## PRODUCT/PROCESS CHANGE NOTICE (PCN)

PCN #: <b>TB1311-02</b> DATE <b>December 24, 2013</b> Product Affected: <b>P9025-0AHGI8 shipped in Tape &amp; Reel</b>  Date Effective: <b>March 24, 2014</b>	MEANS OF DISTINGUISHING CHANGED DEVICES: <input type="checkbox"/> Product Mark <input type="checkbox"/> Back Mark <input type="checkbox"/> Date Code      Shipment starting from March 24, 2014. <input checked="" type="checkbox"/> Other
--	--

### ATTACHMENT I - PCN #: TB1311-02

**Detail of Change:** This notification is to advise our customers that IDT has qualified a new revision of a carrier tape.

**Figure1: Illustration of Existing & New Unit Loading Orientation in Carrier Tape**

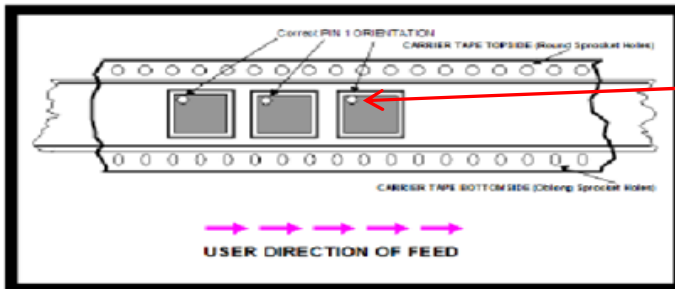
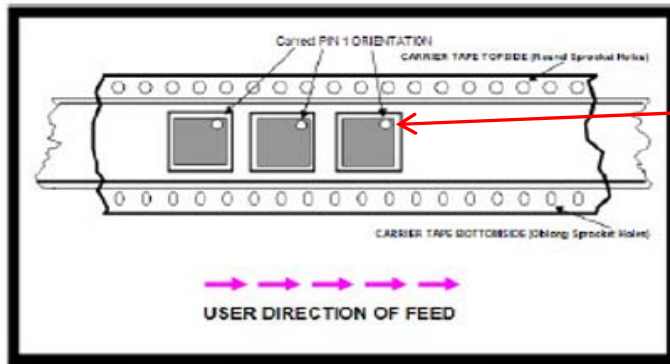
In addition, unit loading orientation in the carrier tape will be changed from Quadrant 1 to Quadrant 2.

Existing Orientation - Quadrant 1

Pin 1 at Quadrant 1

New Orientation - Quadrant 2

Pin 1 at Quadrant 2

**Figure2: Illustration of Existing Carrier Tape Pocket and New Carrier Tape Pocket**

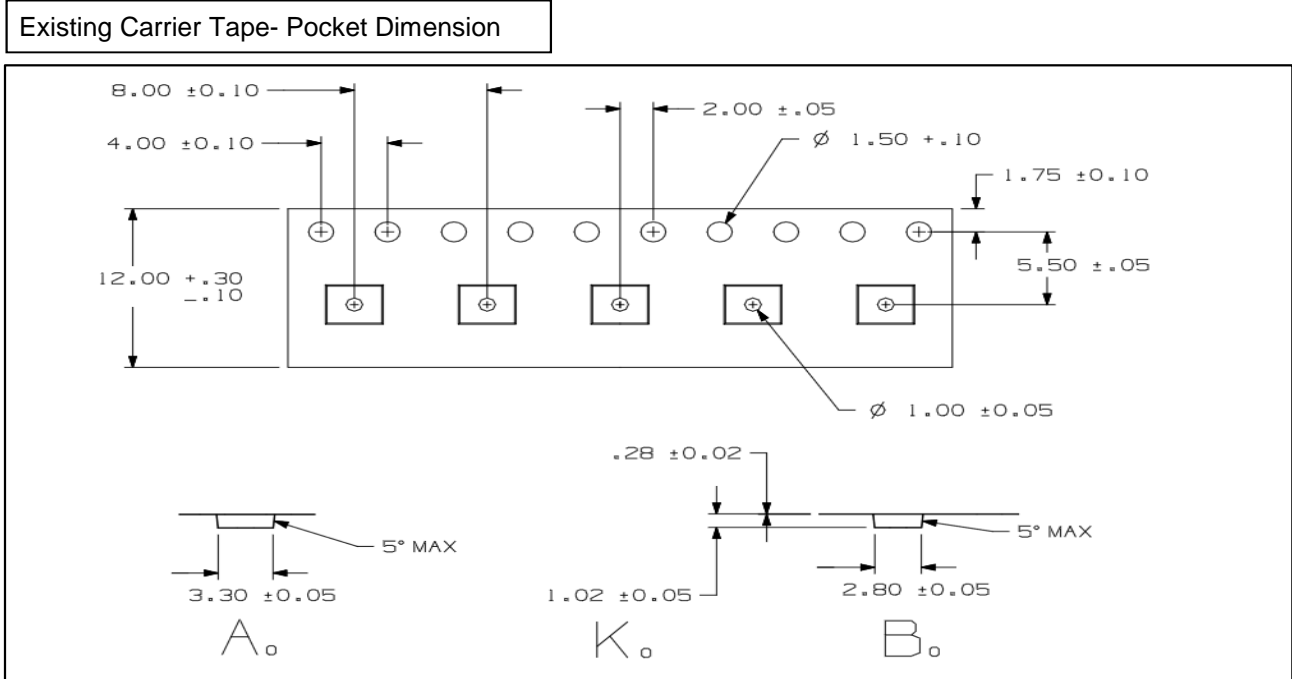
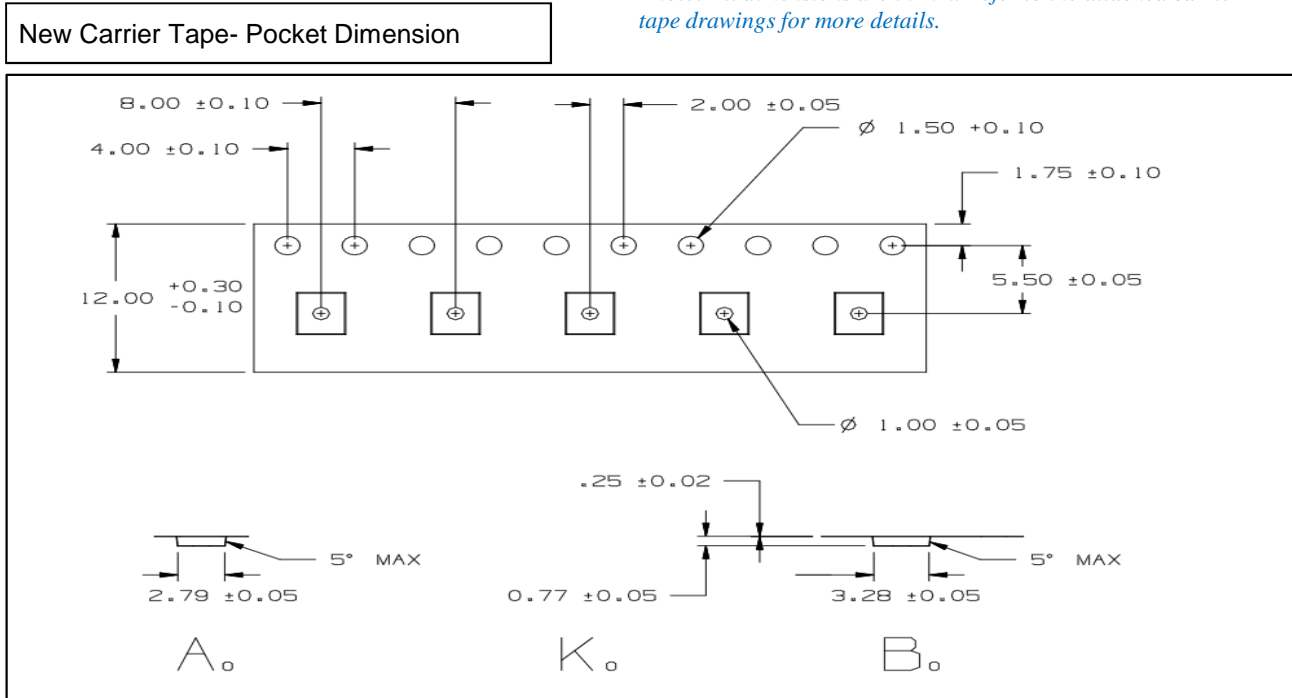
The new carrier tape has changes in pocket depth and design however the carrier tape pitch and width remain unchanged.

Refer to to Table 2, Figure 1, 2 and 3 for the comparison of the existing and new carrier tape in terms of carrier tape pocket dimensions, pocket designs and unit loading orientation respectively.

**Figure3: Illustration of Existing Carrier Tape Pocket and New Carrier Tape Pocket**

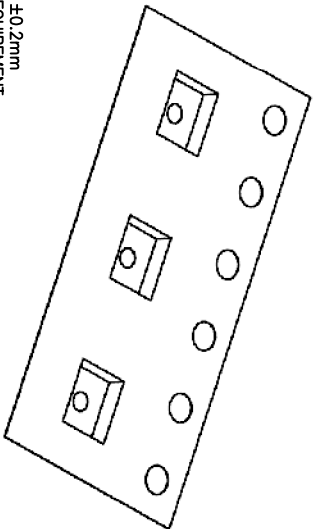
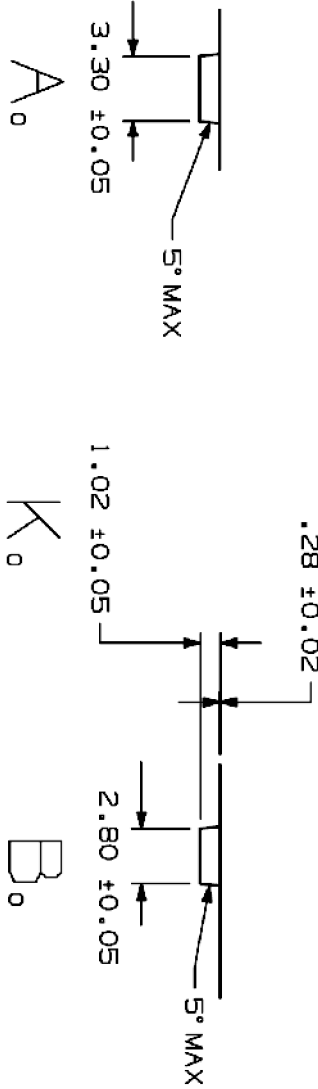
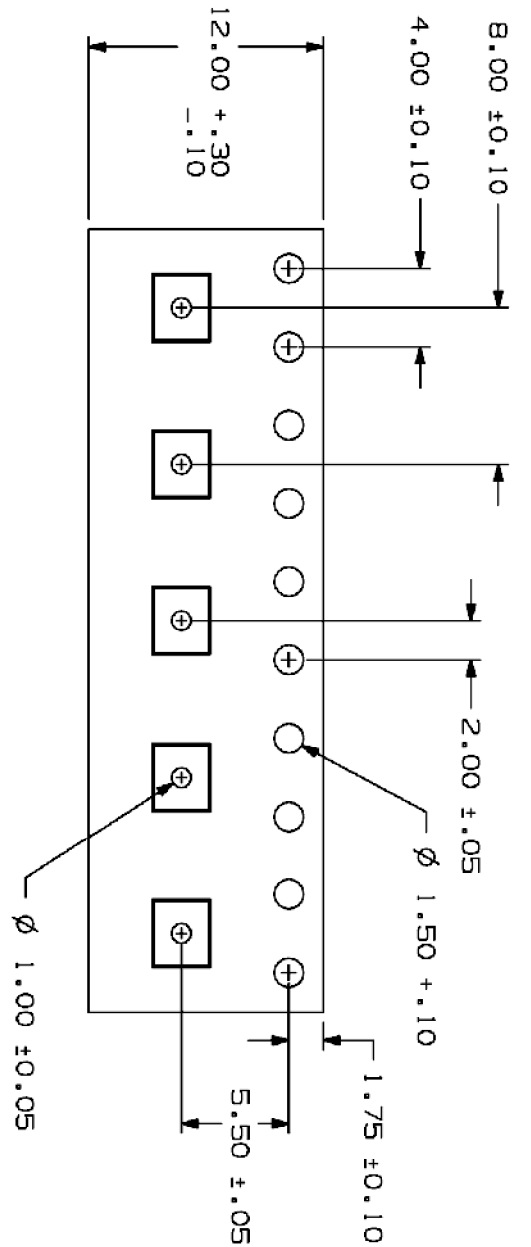
Existing Carrier Tape-  
Pocket Design

New Carrier Tape-  
Pocket Design
